City of Denton

AGENDA INFORMATION SHEET

Hold a public meeting and consider an application for a Certificate of Appropriateness (COA), in accordance with Section 2.9.2 of the Denton Development Code, to restore the awning at the commercial building located at 118-120 N Locust Street. The site is located on the east side of N Locust Street between E Oak Street and E Hickory Street within the Denton Square District. (COA26-0002, 118-120 N Locust Street Awning Restoration, Cameron Robertson)

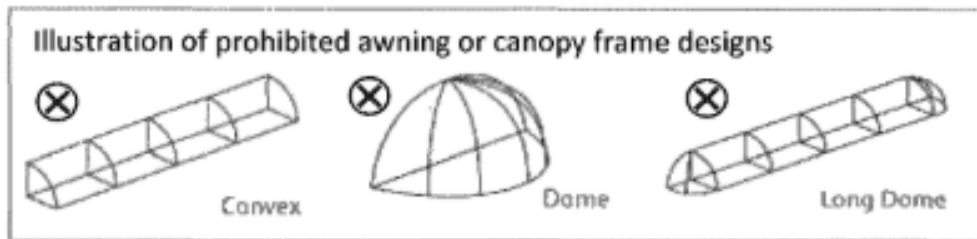
The proposed project would reintroduce an awning to the building, providing covered entries.
